PRELIMINARY OVERALL DEVELOPMENT PLAN
for
SONOMA RANCH SUBDIVISION
POADP #700A

City of San Antonio
NEW U.D.C.
Master Development Plan and P.U.D. 03
APPLICATION

The City Staff Development Review Committee has reviewed Sonoma Ranch 700-A Master Development Plan M.D.P. # 700-A. Please find enclosed a signed copy for your files. Your plan was accepted, however please note the following:

RE: Sonoma Ranch II POADP Plan Revision

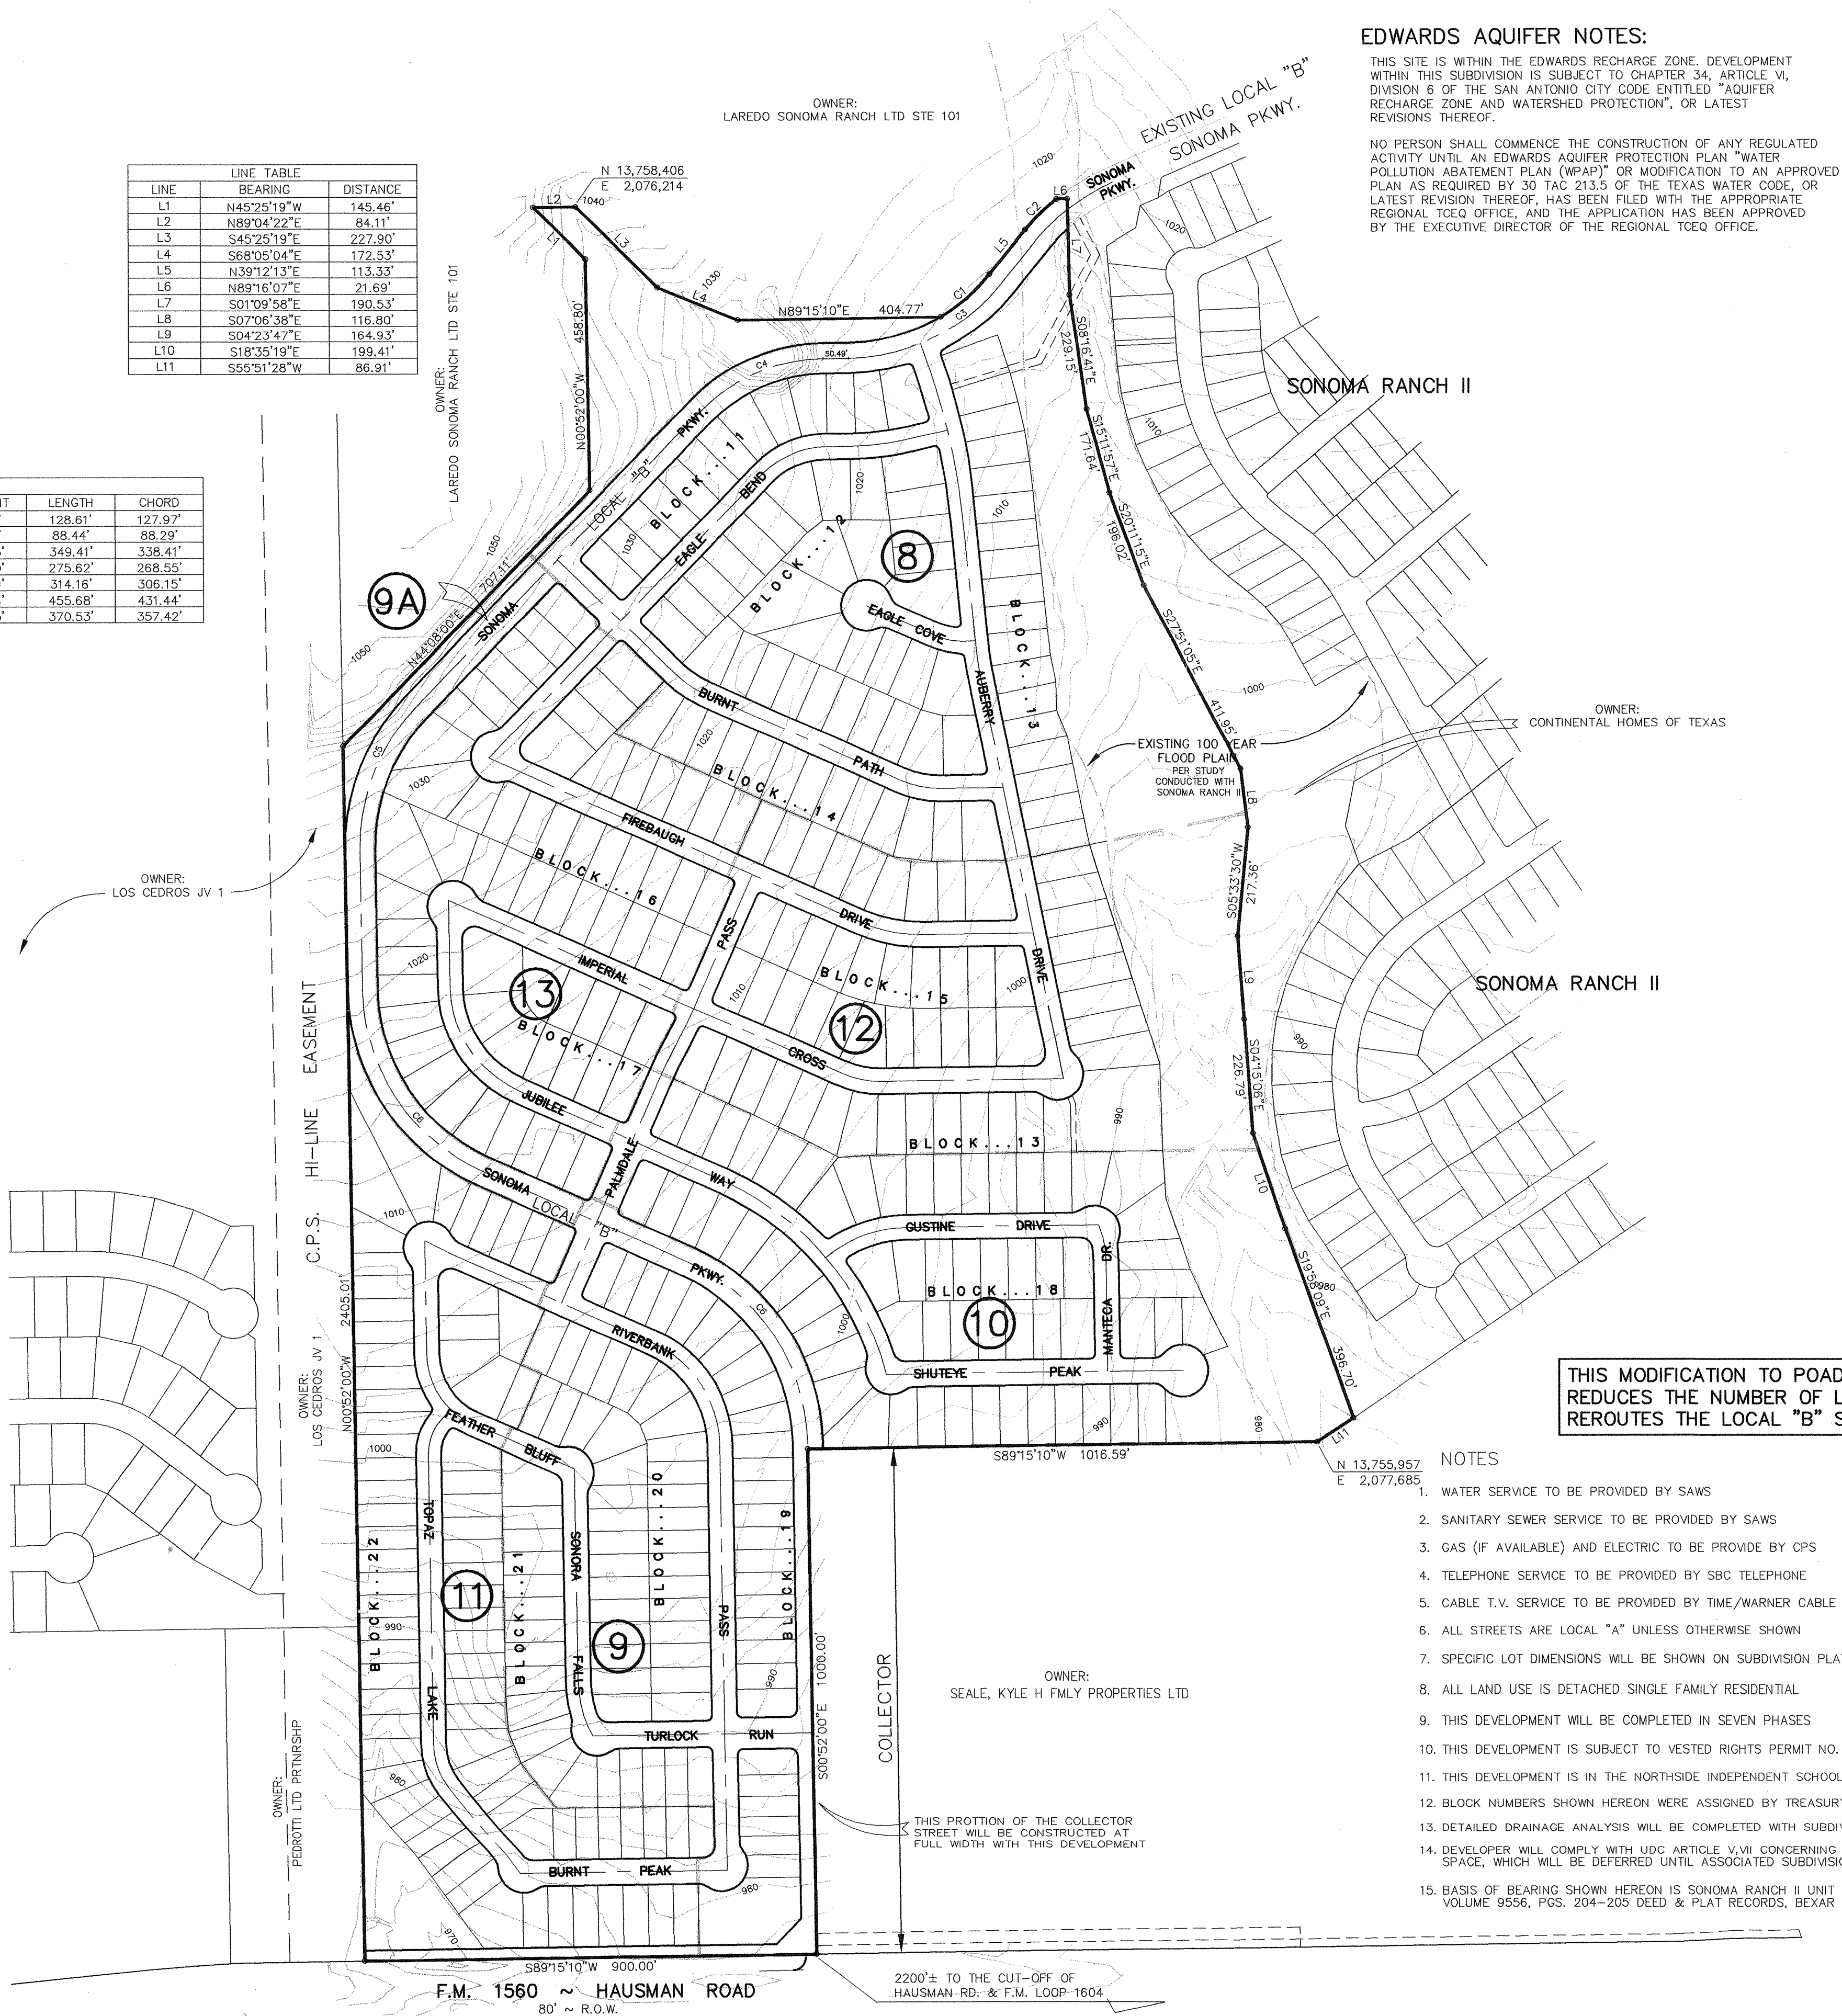
REVISIONS: 5/29/03
ADDED CL. CURVE
DATA

THIS MODIFICATION TO POADP #700
REDUCES THE NUMBER OF LOTS &
REROUTES THE LOCAL "B" STREET

LOCAL "B"
NOT TO SCALE

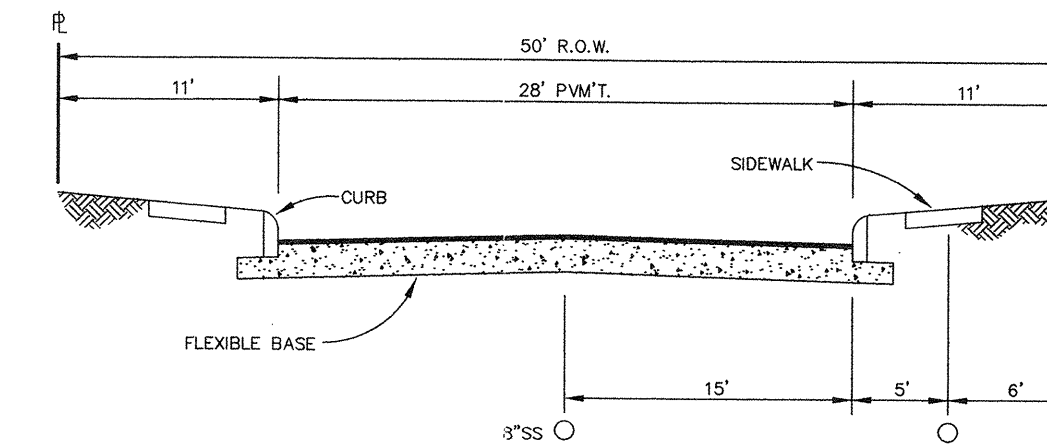
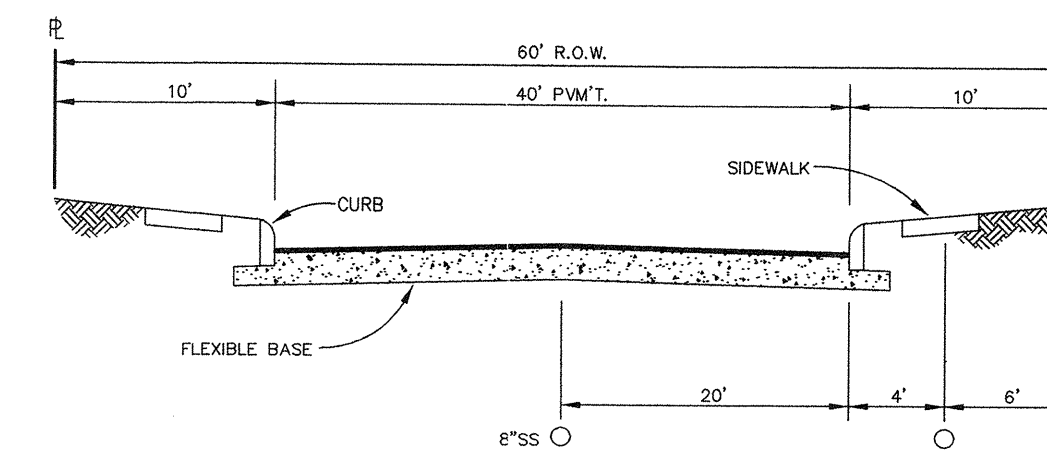
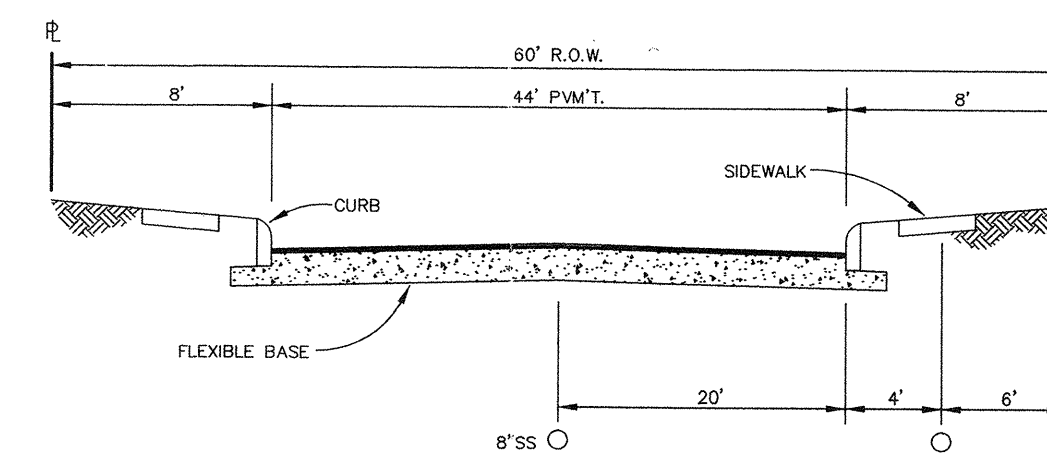
Hey guys...
after talking to Gary Balbaugh on this one...
he's telling me that the 60' ROW has
been accepted by everyone as the
Collector Dedication... Is this true?
If so, then I have no choice but to release this
one, for that is my last comment. Except for my general statement which should be included in the
approval....
